REV.	DATE	DESCRIPTION	BY	APVD
A	2025.09.15	ADHESIVE FROM SONY G9000 CHANGE TO Dexerials T911, PART NUMBER FROM 3MD464TH010 CHANGE TO 3MD464TH01A.	Ferris Tsai

RANGE OF DIMENSION	TOLERANCE CLASS DESIGNATION f	V m	c	THIRD ANGLE PROJECTION	UNITS:mm	SCALE: 1/1	SHEET: 1 OF 1	MODEL NO.: GUP2732CMI
					MATERIAL:		TREATMENT:	
UP TO 30	±0.10	±0.20	±0.50	DSGD by Ferris Tsai	2019_06.26	PART NAME: SENSOR PAD		
ABOVE 30~120	±0.15	±0.30	±0.80	CHK by				
ABOVE 120~315	±0.20	±0.50	±1.20	APVD by	2025-09-15	PART NO.: 3MD464TH01A	REV. A	
ABOVE 315~1000	±0.30	±0.80	±2.00	APVD NO.:	3D FILE NAME: 3MD464TH01A-SENSOR_PAD	DIVA Laboratories, Ltd.		
ANGLE ±1° (±1.75/100)

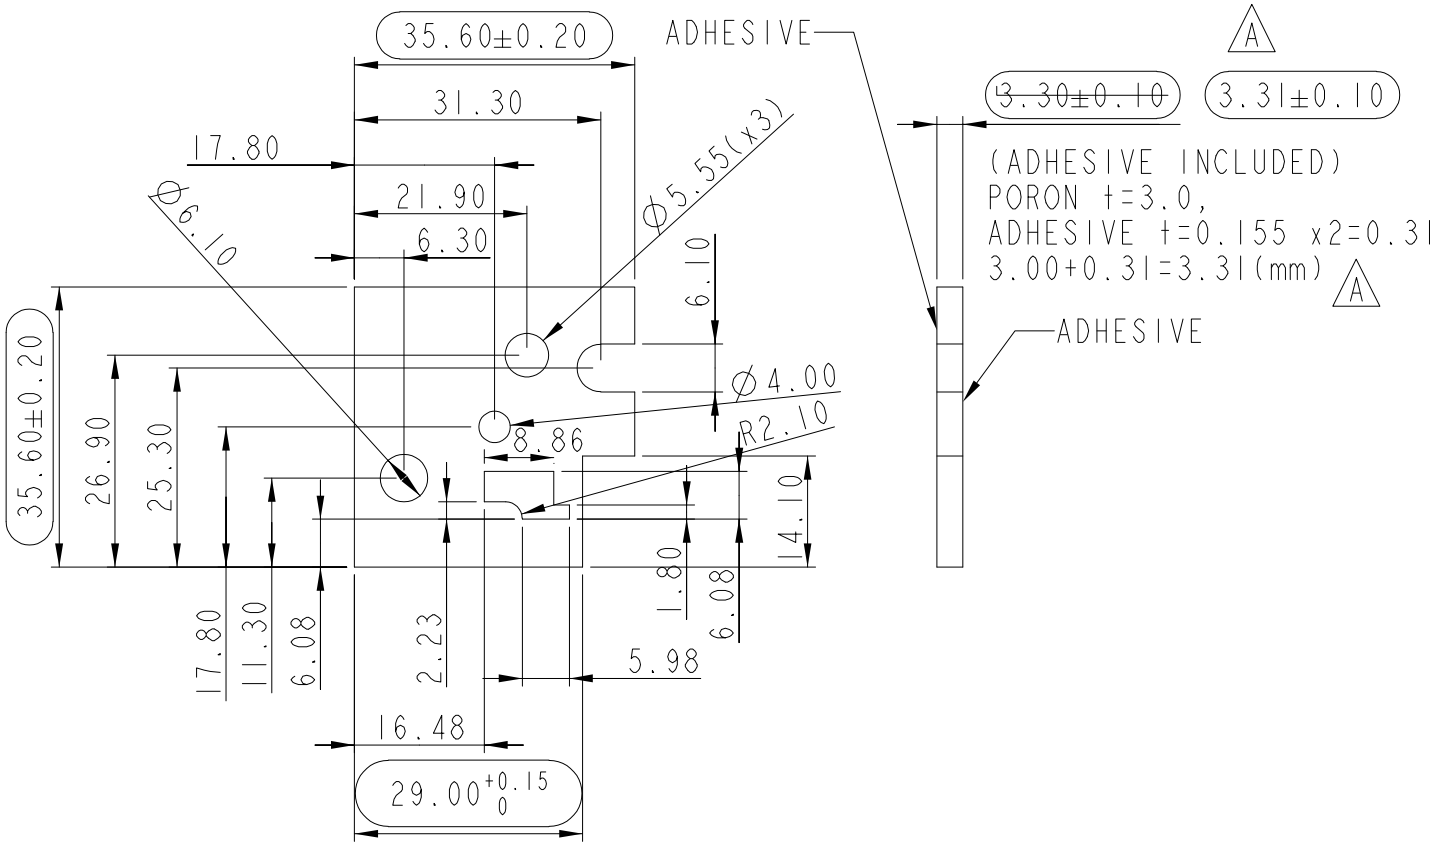
NOTE:
1. MATERIAL: PORON(HH-48), t=3.0mm
2. COLOR: BLACK
3. ADHESIVE: ~~SONY G9000, t=0.15mm(DOUBLE SIDE)~~
   A Dexerials T911, t=0.155mm(DOUBLE SIDE)
4. RoHS COMPLIANT
5. DIVA QC INSPECTION DOCUMENT NO.:QWI-024
